# Application for URBAN DESIGN COMMITTEE Review

Project Name: Belmont Road Roundabout

Below are our response to UDC/PC recommendations:

DECEMBER 5, 2015

DESIGN BY: M. FLEMING	REVIEWED BY:	FIELD NOTES: FB-XX, pp XX-XX	SCALE: HORIZ 1"=30'	DATE: 11/06/15	SHEET: 2K(1)	DRAWING NO: 0-28661
-----------------------	--------------	------------------------------	---------------------	----------------	--------------	---------------------

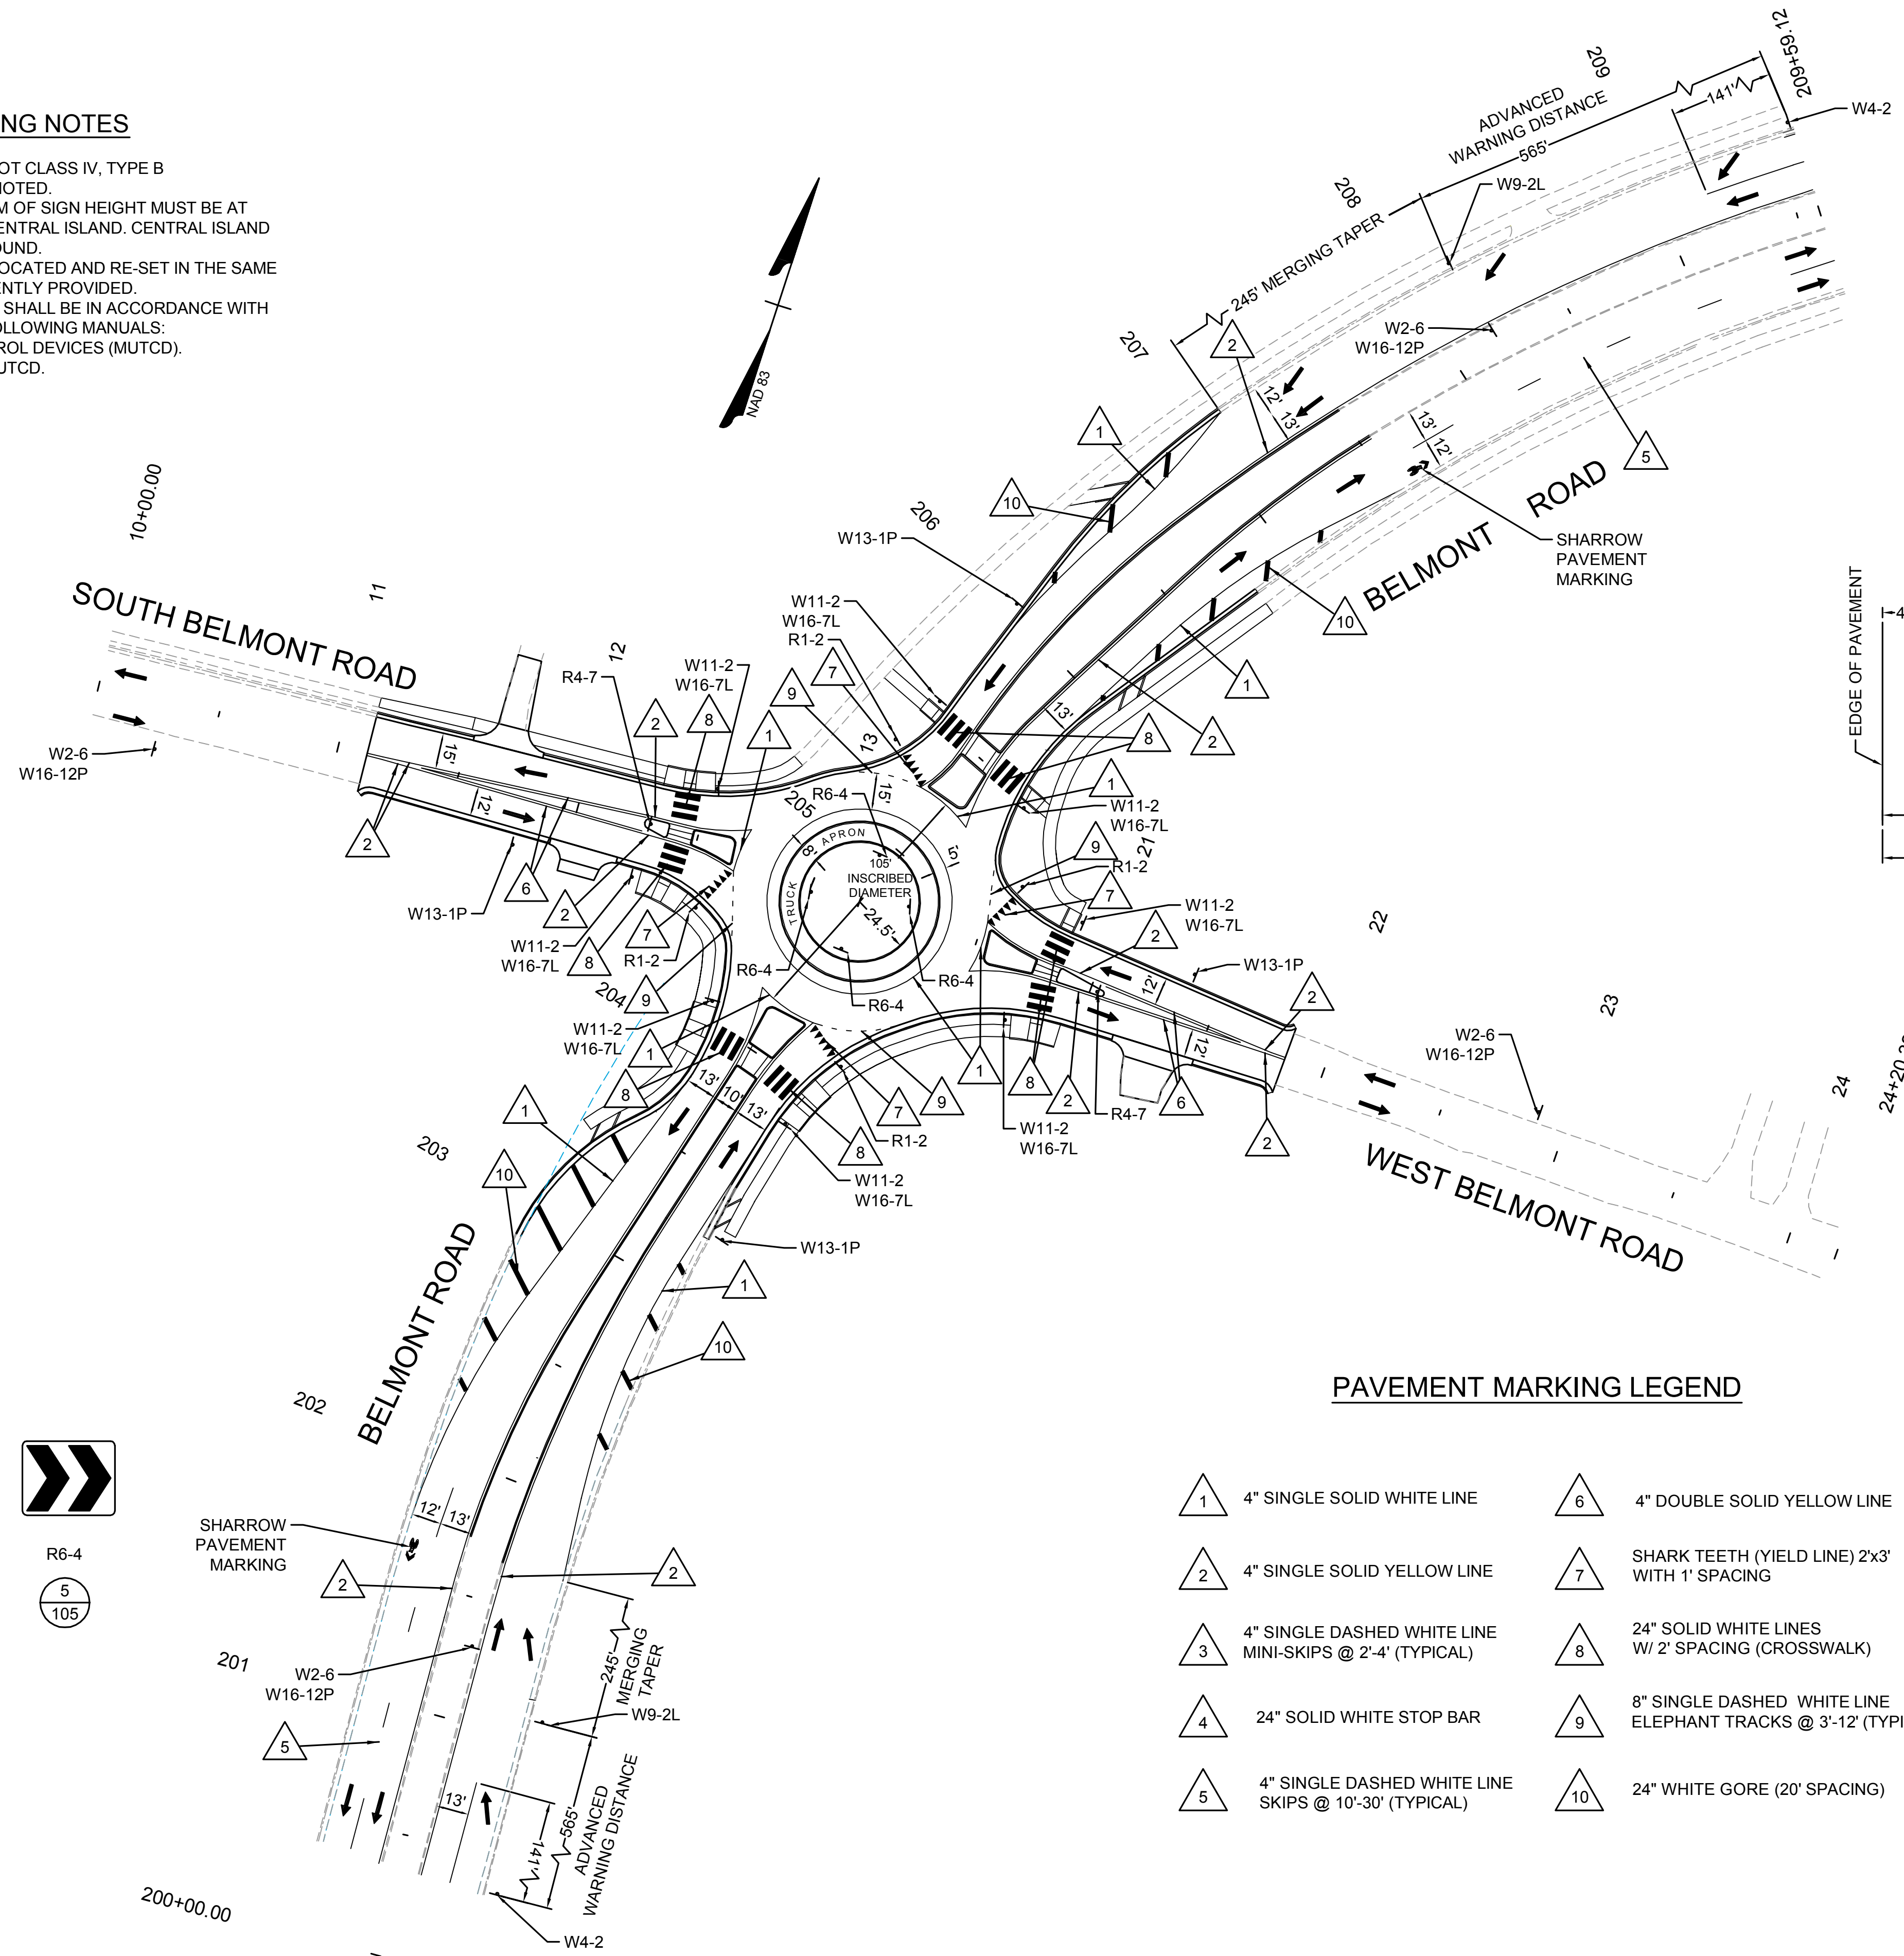
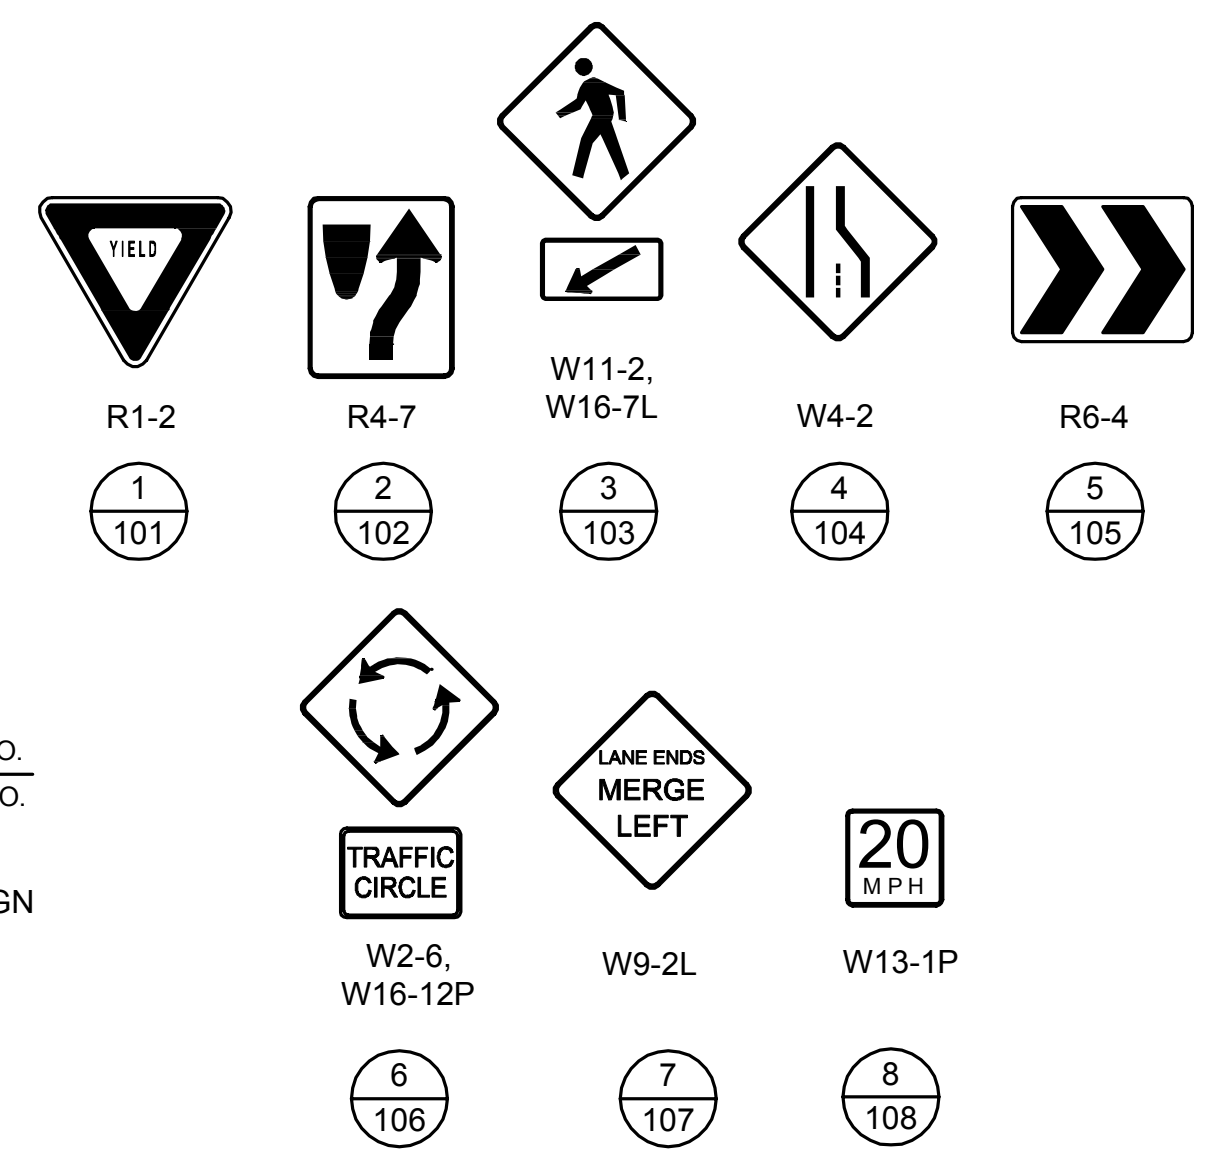
- (9) That the final plans include a signage plan. **These final plans include a signage plan (sheets 2K(1) and 2K(2)) as requested.**
- (10) That the applicant consider working with the Public Art Commission on an installation in the landscaped island. **This items has been sent the information to the Public Art Commission. It should be noted that if the Public Art Commission does add a feature to the central island that the landscape plan would need to be modified to work in conjunction with the feature(s) envisioned.**

BELMONT ROAD ROUNDABOUT  
DETAIL LANDSCAPE PLAN

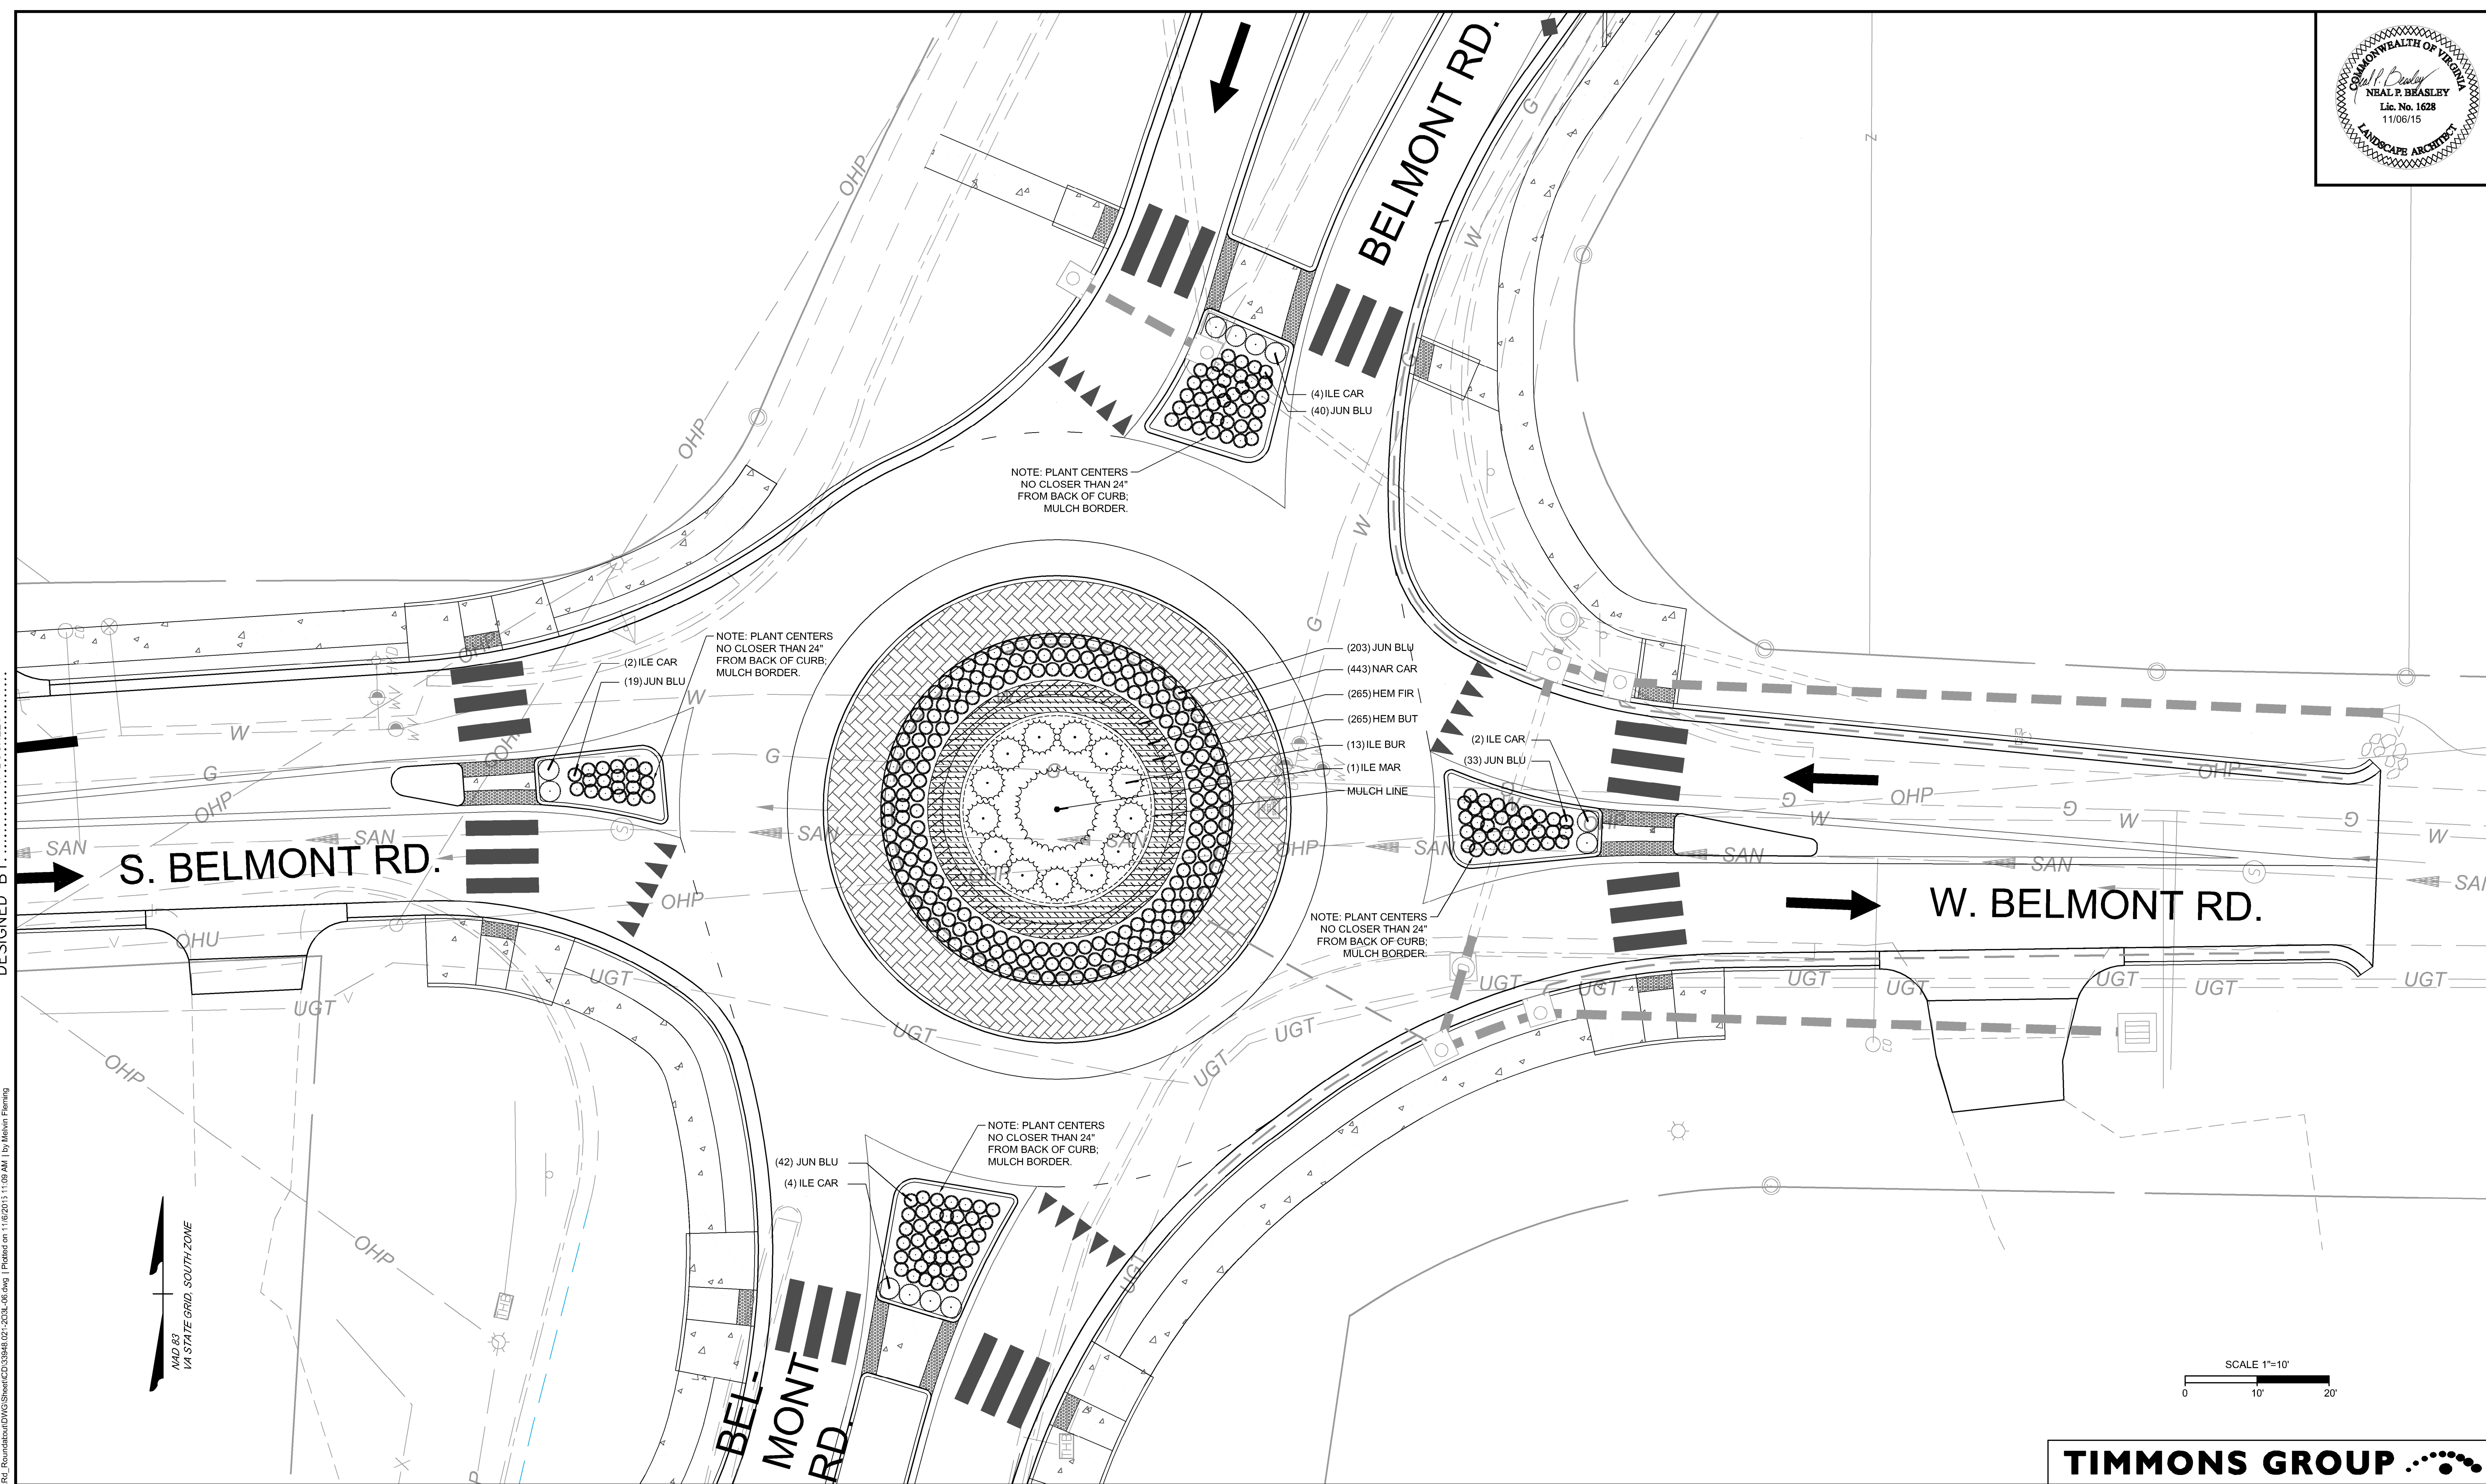
- (1) That the applicant consider reducing the apron width, with the excess used to enlarge the central landscaped island. **The central landscaped island has been increased by 7’ from that which was shown at the preliminary meeting. The inside radius increased from 16’ to 24’ which allows for more area for vegetation and planting.**

- (3) That the applicant considers providing a larger shade tree (or multiple smaller trees) in the central landscaped portion of the roundabout in addition to the concentric rings of evergreen hedge, perennials/bulbs and an evergreen ground cover. **We considered utilizing larger shade trees in the central island portion of the roundabout in addition to the concentric rings of plantings as requested but determined that we would conflict with the existing underground utilities (city gas line, city sanitary sewer line, and city waterline) and the existing overhead (Dominion Virginia Power line).**

- (6) That the applicant landscapes the splitters on W Belmont Rd. **We have removed the plain concrete splitter islands at the noses of the new splitter islands as requested. These plantings are shown on the landscape plan.**
